U S NAVY RESPONSE TO REGULATOR COMMENTS TO RCRA FACILITY INVESTIGATION
REPORT ADDENDUM AND CORRECTIVE MEASURES STUDY WORKPLAN AREA OF
CONCERN 569 AND 570 AND 573 (AOC 569 AND 570 AND 573) ZONE E WITH
TRANSMITTAL CNC CHARLESTON SC
3/10/2003
CH2M HILL

Re: CH2M-Jones' Responses to Comments by EPA regarding the *RFI Report Addendum and CMS Work Plan, AOCs 569, 570, and 578, Zone E, Revision 0*

Figure A-1
 RFI Soil Sampling Locations
 Potentially Impacted by
 Proposed Realignment of Hobson Ave
 AOCs 569, 570 & 578, Zone E
 Charleston Naval Complex

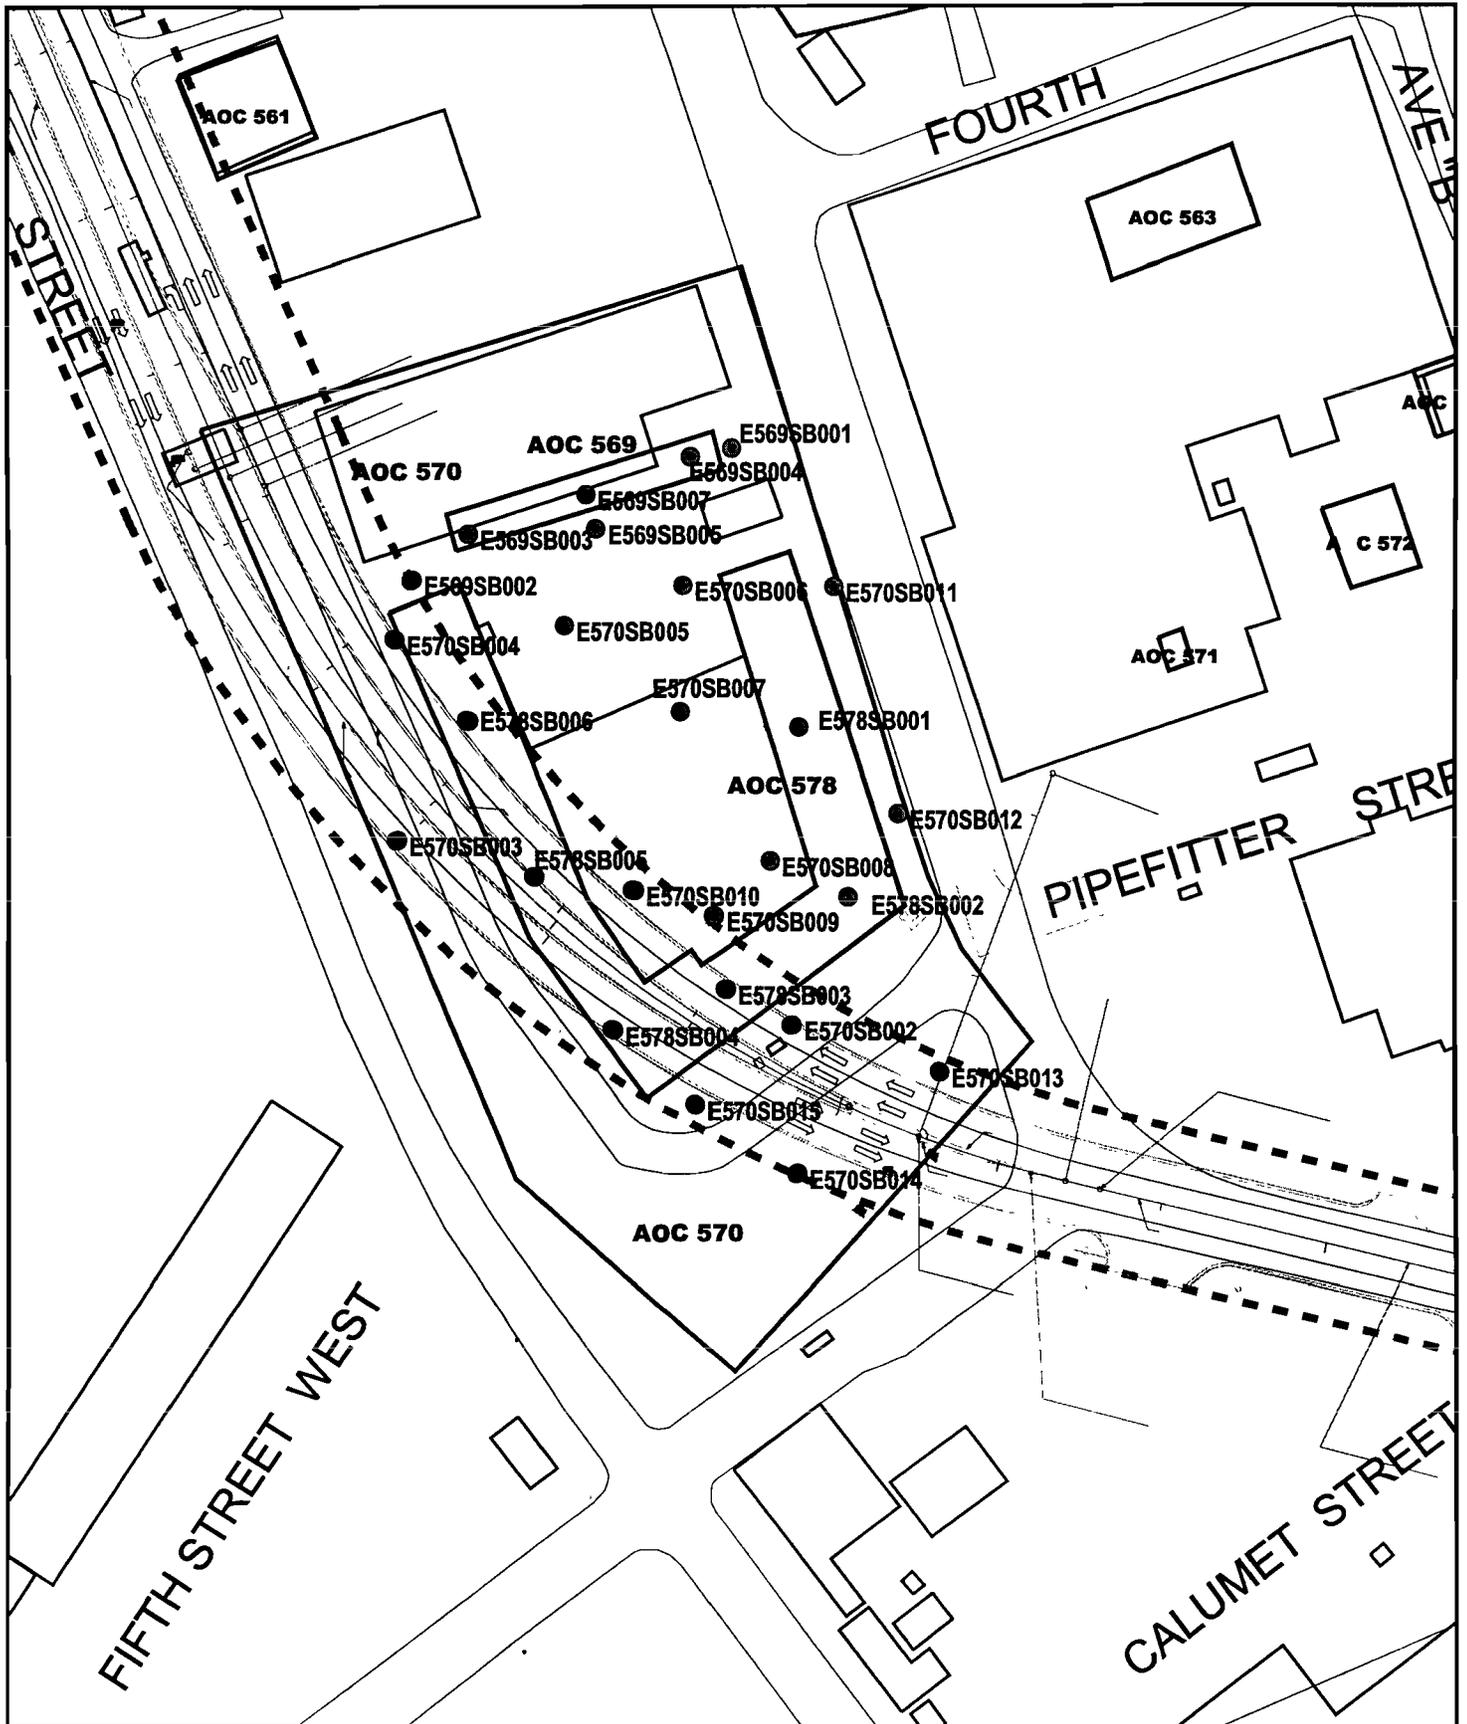
1. Page 1-2, Lines 21-23.

The text indicates that the realignment of Hobson Avenue will overlay the current locations of AOCs 569, 570, and 578. Additional information should be provided regarding the proposed realignment that would include, at minimum, a diagram of the proposed roadway realignment. Of interest would be the areas to be impacted by excavation of a new road bed and whether the adjacent areas would become unpaved medians, drainage areas, etc., as these details may have an impact on the evaluation of risks and the land use controls that may be necessary.

The attached figure (Figure A-1) shows the proposed footprint (90-percent design stage) of the Hobson Avenue realignment and the RFI soil boring locations that fall within this footprint. As shown in this figure, the only soil boring location with identified COCs that falls within the footprint of the roadway realignment is E578SB005, where a BEQ detection of 1.619 mg/kg in surface soil exceeds the CNC BEQ sitewide reference concentration for surface soils of 1.304 mg/kg. The subsurface soil BEQ detections at this location of 0.323 mg/kg did not exceed the CNC BEQ sitewide reference concentration for subsurface soils of 1.4 mg/kg.

Should the realignment of Hobson Avenue be implemented as shown in the attached Figure A-1, the existing pavement and surface soils in the location of E578SB005 will likely be excavated and repaved with asphalt. Since asphalt material consists of a significant concentration of the PAHs that make up the BEQs, the risk of human exposure to the existing soil BEQ concentrations at this location are no greater and are likely much less than that encountered during the asphalt paving activities.

It should be noted that with the exception of two surface soil BEQ detections above the CNC sitewide reference concentration, none of the other COCs showed detections above the EPA Region III residential RBCs, thereby indicating that direct exposure from other soil COCs identified at the site are not of concern. The other surface soil COCs were identified based on detections that exceed of their SSLs (with a DAF=1). BEQs are known to be associated with asphalt pavements, and it is likely that a roadway realignment project will increase the potential risk of exposure to BEQs. None of the other soil boring locations showing the COCs are likely to be impacted by the realignment project as proposed. CH2M-Jones is conducting additional delineation sampling for BTEX at E569SB005, and an evaluation will be made after this sampling for excavation of soils around this boring location. The remaining COC locations of E569SB012 and E578SB005 will likely not be disturbed by the Hobson Avenue realignment project and will continue to exist under pavement.

The above information will be included in the Revision 1 of this RFIRA, and will be taken into consideration during the preparation of the CMS Report for this site.
